We are grateful for the constructive and detailed comments of Prof. Shiva P. Pudasaini and Reviewer 2. In accordance with their helpful and insightful recommendations, we have modified the original manuscript to both improve the presentation and strengthen the discussion on the limitations and potential of the results derived from our reduced-scale flume tests.

Associate editor COMMENTS AND AUTHOR RESPONSE

Reviewer 1 COMMENTS AND AUTHOR RESPONSE

Reviewer 2 COMMENTS AND AUTHOR RESPONSE

Figure 8:

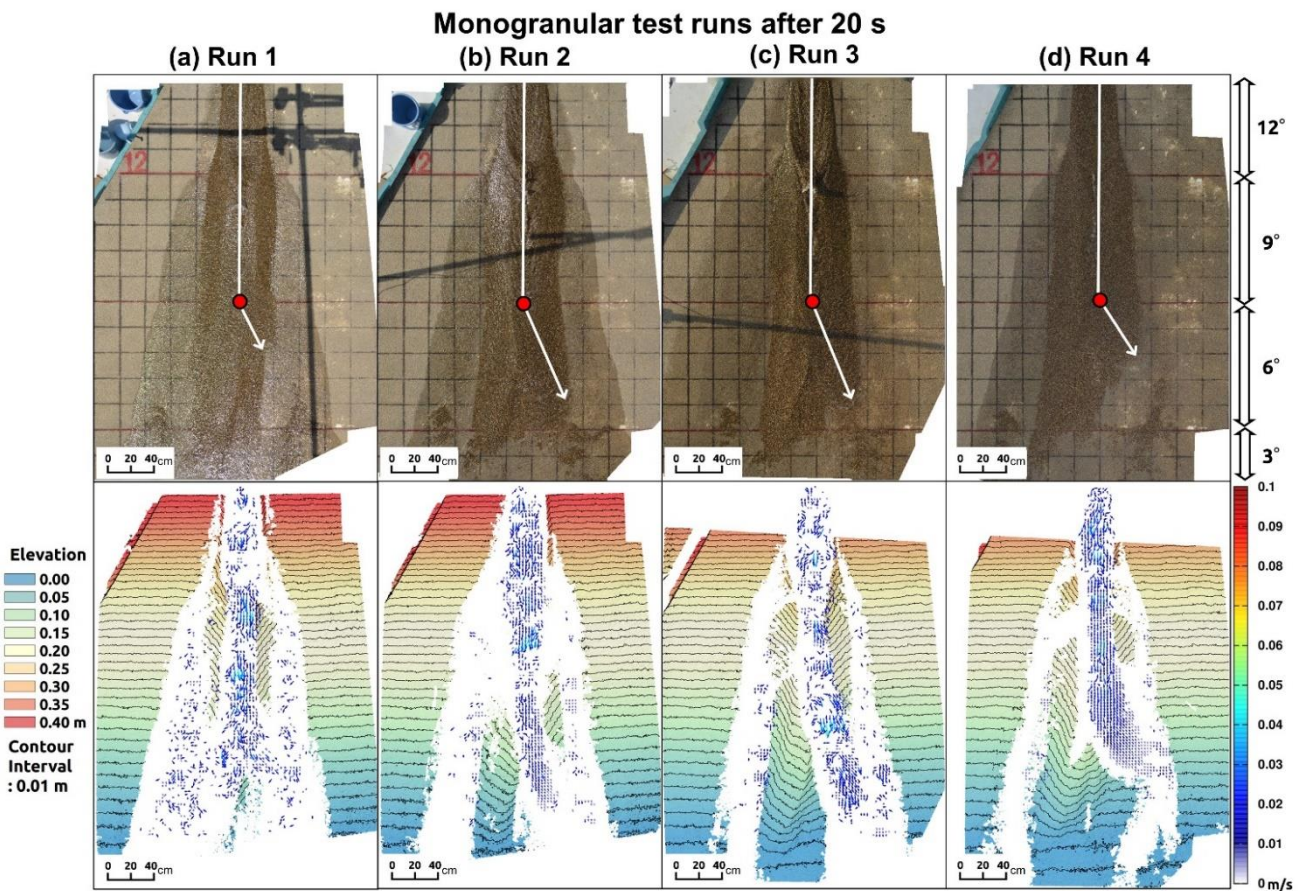
R1 Specific comment 8: *Fig. 7-8 (etc.): The quality is poor.*

Reply to R1 Specific comment 8: To improve clarity and quality, we have indicated the location of the point of the avulsion in Figs. 8–13.

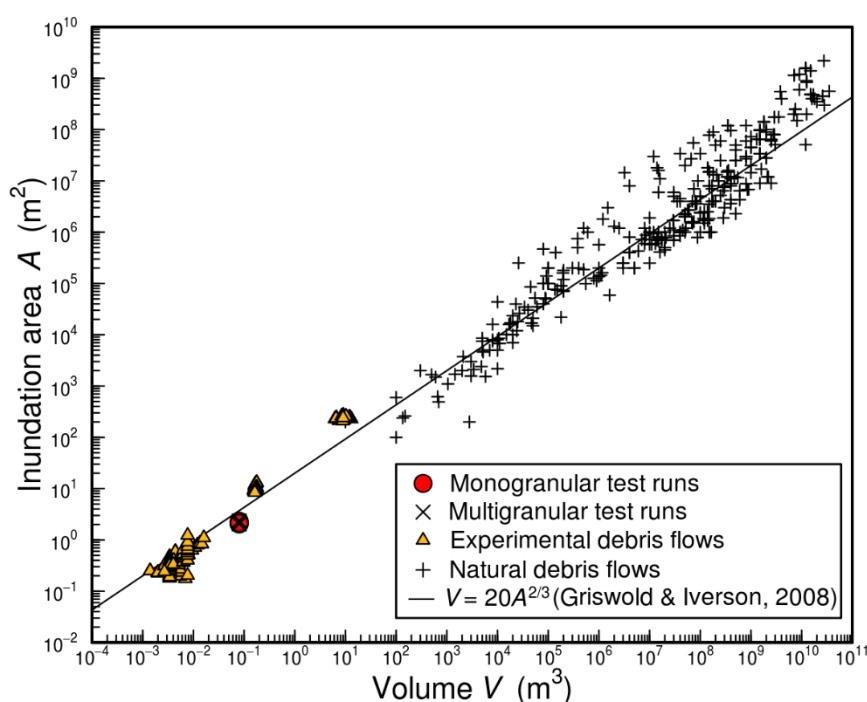
In the experiments described, the fans are produced by a single debris flow like surge resulting from a continual flow entraining sediment from the bed of the flume. However, in reality debris flow fans are produced by multiple flows depositing sequentially over the course of potentially thousands of years. Therefore, it is not currently clear how the deposits from the experiments can be compared to actual debris flow fans. Instead, it is likely these results can help us to decipher single events from fan stratigraphy.

R2 Comment 7: *Line 84: There needs to a definition of what the authors consider a debris flow fan to be and how their experiment replicates this definition. Currently the experiments do not seem to result in a fan as defined by the references discussed in the references of the introduction.*

Reply to R2 Overall comment: We sincerely appreciate your insightful review and constructive suggestions. We agree that our experiment focused on the fan morphology formed by a single successive debris-flow surge rather than that formed by an accumulation of multiple debris-flow surges. This arose because of differences in the study objectives and intentions. We intended to investigate whether differences in the grain-size distribution within debris flows could lead to changes in fan morphology via differences in runout characteristics without considering differences in hydrographs and without considering the effects of geomorphology formed by previous debris-flow surges. To convey our intention and to clarify the study targets, we have revised the related sentences (**P3 L83-96**).

We also acknowledge that we performed only four experimental test runs for the respective grain sizes, and that our flume tests focused on a limited aspect of the effects of the grain-size distribution within the debris flows. On the basis of the similarities between experimental and natural debris-flow fans in terms of qualitative and geometrical comparisons, we suggest that despite the limited number of experimental runs, the experiments were well controlled and could have produced representative results under our experimental setup and operation (**Figure 19** and **P15 L475-496**). Additionally, we have emphasized and carefully discussed the limitations of our flume tests (**P16 L497-516**).

In terms of a geometrical scaling relationship, we compared the relationships between the volumes of the debris flows (V) and the inundation areas of the sediment deposits (A) similar to De Haas et al. (2015b) and Baselt et al. (2022) (Fig. 19). The inundation areas of the monogranular and multigranular test runs were $\sim 2.224 \text{ m}^2$ and $\sim 2.159 \text{ m}^2$, respectively (Table S1), which highlights that when the hydrograph and velocity of debris flows are similar before the start of runout, the effects of grain-size distribution within the debris flows on fan formation are reflected in change in the horizontal shape of the sediment inundation range but without substantial variation in the gross area. Owing to this similarity in the inundation area regardless of the grain-size distribution, all experimental runs were plotted in almost identical locations on the log-log V - A plane, and just below the best-fit regression curve for natural debris flows derived by Griswold and Iverson (2008) (Fig. 19). The V - A scaling relationships indicate that our experimental results are geometrically within the range of natural debris flows, and that our flume tests were well-controlled experiments across all experimental runs, especially regarding the resultant inundation areas. Given this reproducibility of the inundation area, although we performed only four test runs for both the monogranular flows and the multigranular flows, we believe that the obtained observations adequately reflect the representative behavior of experimental debris flows under the operation and setup of our flume tests.

Figure 14:

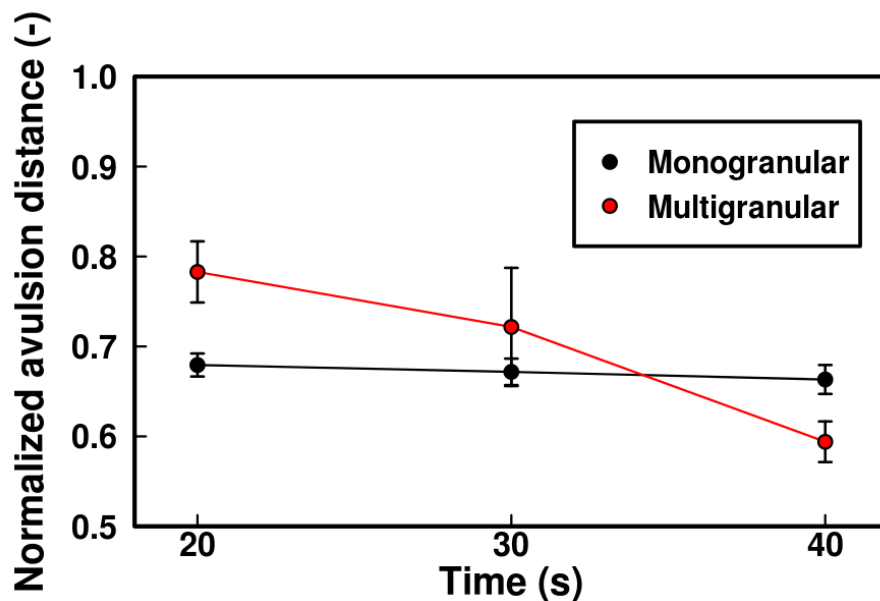
Most of the analysis of the experiment is in terms of time and distance, both of which are highly specific to the experiment run and cannot easily be scaled up to a real debris flow or easily compared between model runs. Throughout the results and discussion, the authors describe how avulsions in multigranular flows occur earlier (both in terms of distance from the flume outlet and in time) than monogranular flows. However, as this result is likely due to the shorter runout distance of the multigranular flows it is not clear whether this result represents a significant difference in behaviour between the 2 types of flow. By normalising the runout length of the flow, it is possible to compare whether the avulsions in multigranular flows truly occur earlier in the evolution of the fan. If there is no difference in the normalised runs then grain size is not a controlling factor on avulsion frequency or location. Normalising the runout length will also allow for comparison between the model results and actual debris flows and debris flow deposits.

R2 Comment 15: *Line 347: The locations of the avulsions cannot be compared between runs due to*

the difference in runout length. Normalising the runout length may indicate that the locations of the avulsions are fairly similar across all of the experiment runs.

Moreover, we compared the normalized avulsion distance (i.e., the ratio between the distance from the flume outlet to the occurrence point of the avulsion and the distance of the runout of the solid phase) (**Figure 14**), which indicated that the avulsion of the multigranular flows occurred closer to the flume outlet in comparison with that of the monogranular flows (**P11 L321-325**). We also compared the surface slope of the final fan morphology between the monogranular and multigranular flows (**Figure 16**). The multigranular flows formed steeper slopes of the fan surface further upstream in comparison with the monogranular flows (**P11 L340-351**). These results support our interpretation and discussion that the short runout distance of the multigranular flows can lead to variations in fan morphology.

P11 L321-325: The normalized avulsion distances of the monogranular test runs were almost constant at approximately 0.67 from after 20 s to 40 s from the start of flow runout (Fig. 14). Unlike this fixed position of the avulsion of the monogranular flows, the normalized avulsion distance of the

multigranular test runs gradually decreased from ~ 0.78 to ~ 0.59 from after 20 s to 40 s from the start of flow runout (Fig. 14). This highlights the difference in the trend of the inundation processes between monogranular and multigranular flows.

Reply to R2 Comment 15: We appreciate this comment. Comparison of the normalized avulsion distances indicated that the locations of the avulsions were different between the monogranular and multigranular flows (**Figure 14** and **P11 L321-325**, please see **Reply to R2 Overall comment**).

Figure 16:

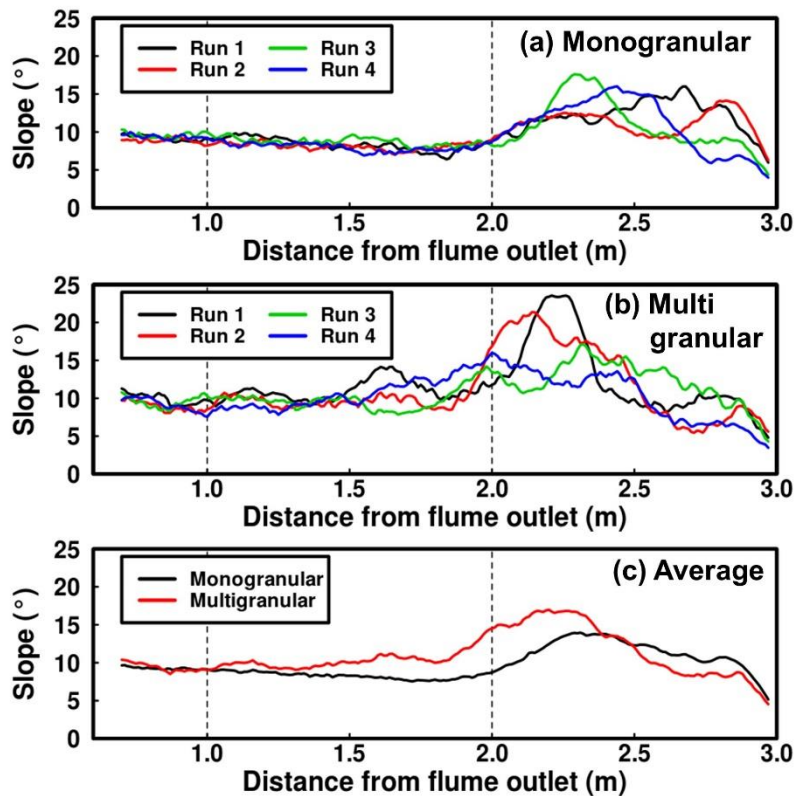
Finally, there is surprisingly little reference to the changing slope of the runout area despite slope being a well-known control on the deposition of sediment. By analysing the slope at which the flows stop at the differences in friction between the flows can be quantified. Multigranular flows may stop in steeper slopes than monogranular flows which could allow for some calculation of the friction angle in the deposited sediment. This result would again help to link the experimental results to real debris

R2 Comment 16: *Line 363: The lack of consideration of the change in slope in the discussion of runout length is strange. An important confirmation of the coarse grains enhancement of friction would be if the multigranular flow stop on steeper slopes than the monogranular flows. This would also allow for easier comparison with real examples of debris flows.*

P11 L340-351: Corresponding to the difference in the runout distance of the solid phase (Fig. 5), the surface slopes along the center of the final fan morphology were different between the monogranular and multigranular flows (Fig. 16). The slopes of the monogranular test runs were similar at ~10° from the flume outlet to ~2 m downstream, but they increased to a maximum of ~15° and became somewhat varied further downstream between experimental runs (Fig. 16a). Similarly, the slopes of the multigranular test runs were similar at ~10° from the flume outlet to ~1.5 m downstream (Fig. 16b). However, the slopes of the multigranular test runs started to increase further upstream in comparison with the monogranular test runs; the slopes increased to a maximum of ~23° from ~1.5 to ~2.2 m downstream (Fig. 16b). These differences, reflected in the averaged slopes, indicate steeper surface slopes of the multigranular-fan morphology (Fig. 16c). Note that beyond 2.5 m downstream, the deposition thickness of the multigranular test runs was close to zero (Fig. 15b), indicating that the slope values do not represent the surface slopes of the final fan morphology. Indeed, in the section from 2.5 to 3.0 m downstream from the flume outlet, the slopes of the multigranular test runs were gentler (i.e., ~6°–8°) and closer to the surface slope of the deposition area (6°) in comparison with the monogranular test runs (Fig. 16c).

Reply to R2 Comment 16: We appreciate this comment. Comparison of the surface slope of the final fan morphology indicated that the multigranular flows resulted in a steeper surface slope in comparison with that of the monogranular flows. This aspect is reflected in the revised manuscript (**Figure 16** and **P11 L340-351**, please see **Reply to R2 Overall comment**).

Figure S1:

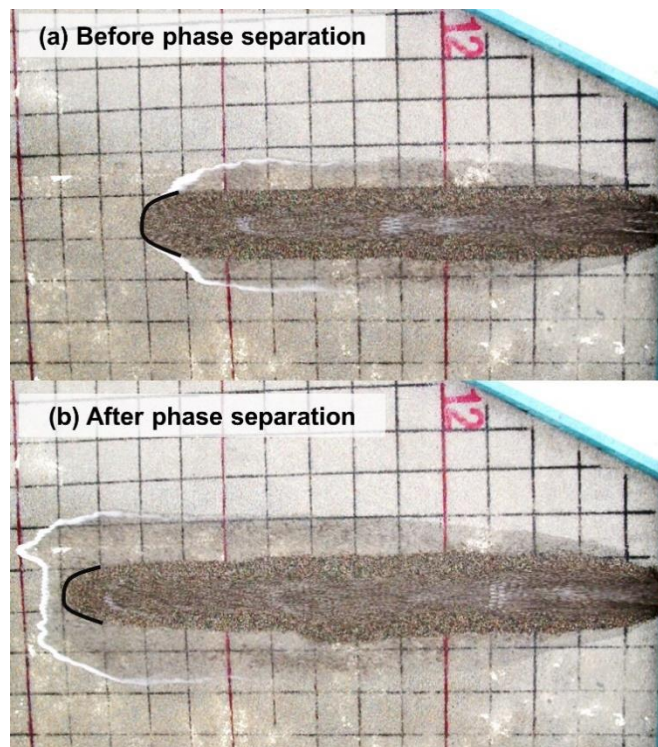
R2 Comment 9: Line 173: How are the solid and fluid phases identified and defined?

Reply to R2 Comment 9: To improve clarity, we have added new figures (**Figures S1 and 2**) and referred to them as appropriate in the main text (**P6 L179-186**):

P6 L179-186: We measured changes in the runout distance of the fronts of the generated debris flows with temporal resolution of 0.1 s using the captured video and the grid lines drawn in the deposition area. During the early stage of debris-flow runout, the solid phase (sediment particles) and fluid phase (clear water) descended synchronously as a complete granular–water mixture flow (Fig. S1a), but then they flowed separately with different velocities in accordance with the deceleration of the solid phase (Fig. S1b). Because the timing of the phase separation was clear in all experimental cases, we measured the fronts of both the solid and the fluid phases after separation to compare the extent of phase separation between the monogranular and multigranular flows. The runout distances of the solid and fluid phases were defined as the distance from the flume outlet to the front of the solid and fluid phases, respectively (Fig. 2).

Figure 2:

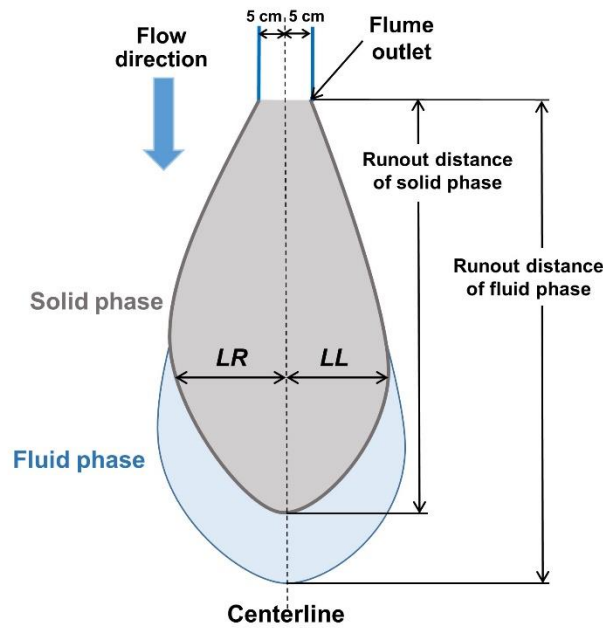
R2 Comment 10: *Lines 200 – 205: The calculation of this metric could be better explained by diagram, currently it is not clear how the mid line is defined or what “the length of the fan from the midline to the edge...” describes.*

R2 Comment 11: *Line 237: How is the runoff distance measured and defined? Does the runout begin in the flume or once it enters the deposition zone?*

Reply to R2 Comment 10: We appreciate this comment. We have added a new figure to explain the definitions (**Figure 2**, please see **Reply to R2 Comment 9**) and we have revised the related sentences that describe these definitions (**P8 L224-228**):

where LL and LR represent the length of the fan from the centerline of the flume to the edge of the left-bank side and to the edge of the right-bank side of the fan shape, respectively (Fig. 2).

P6 L185-186: The runout distances of the solid and fluid phases were defined as the distance from the flume outlet to the front of the solid and fluid phases, respectively (Fig. 2).

Figure 6:

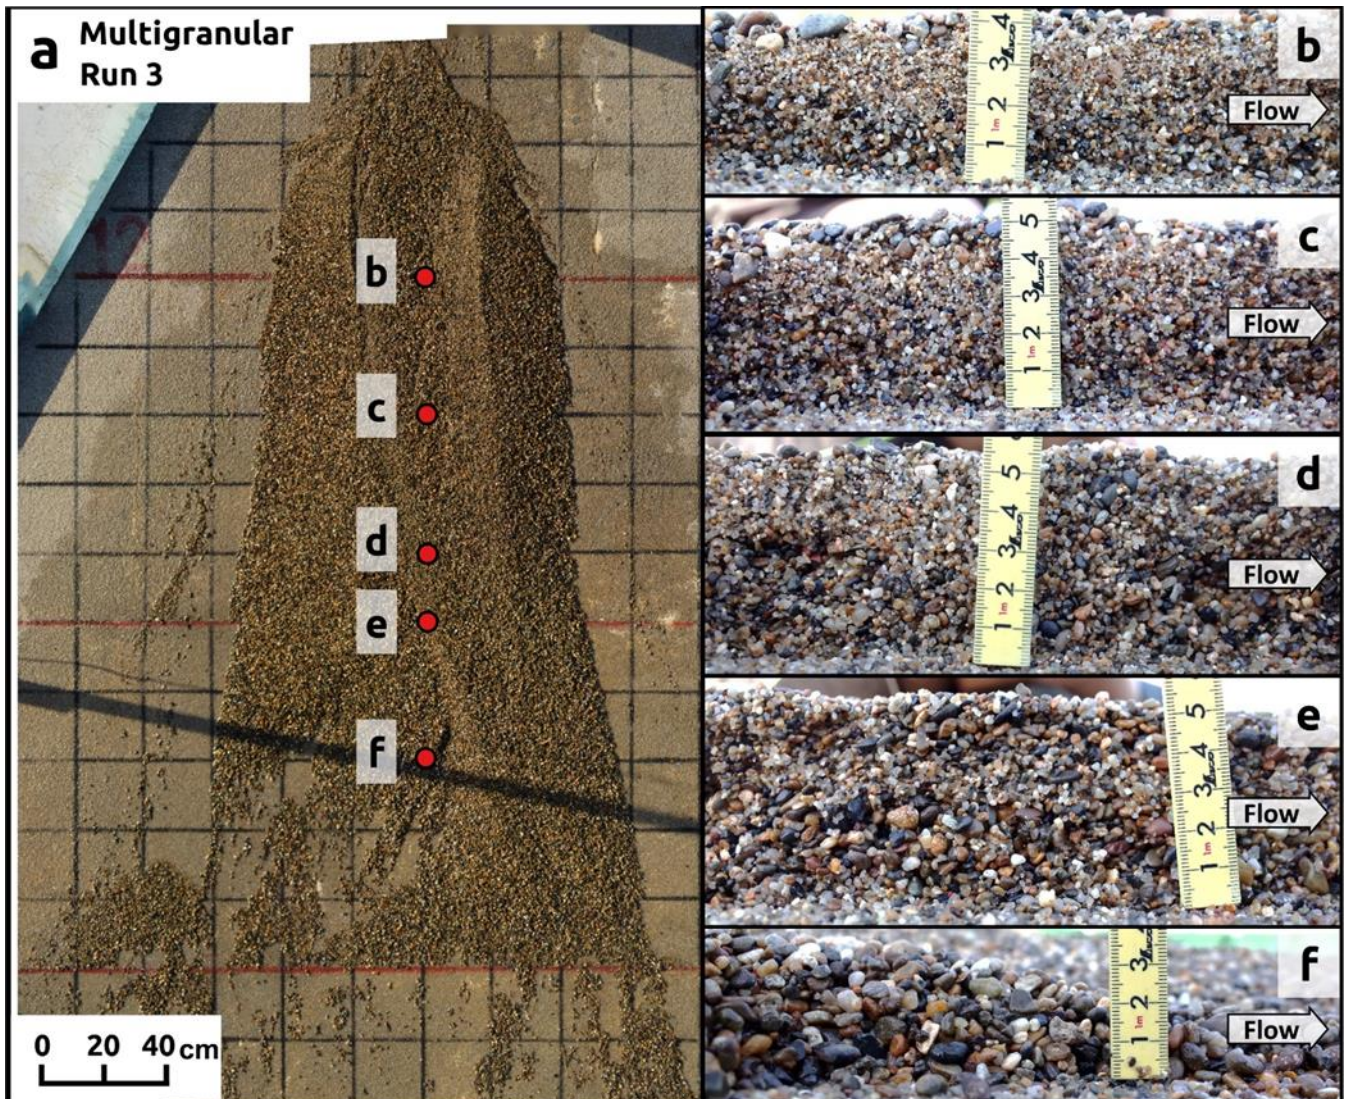
R1 Specific comment 7: *Fig. 5-6: Panels b-f: are these vertical sections?*

R2 Comment 13: *Lines 267-270: It is not clear what a depth of 1-2cm from the surface of the deposition area means. Are the coarser grains 1-2 cm above the base or 1-2 cm below the surface of the deposit? It is also not clear whether the deposit is fining upwards or has reverse grading.*

Reply to R1 Specific comment 7: We apologize for the confusion. To indicate the flow direction, we have revised Figs. 5 and 6 (please see **Reply to R2 Comment 13**).

Reply to R2 Comment 13: We appreciate this comment. We have revised the related sentences to improve clarity, and we have modified Figs. 6 and 7 to indicate the direction of the measurement profiles (**P10 L292-294** and **Figures 6 and 7**).

P10 L292-294: At all observation points, relatively large particles were deposited above the base of the deposition area (i.e., zero on the ruler) to thickness of ~1–2 cm (Figs. 6b–f and 7b–f).
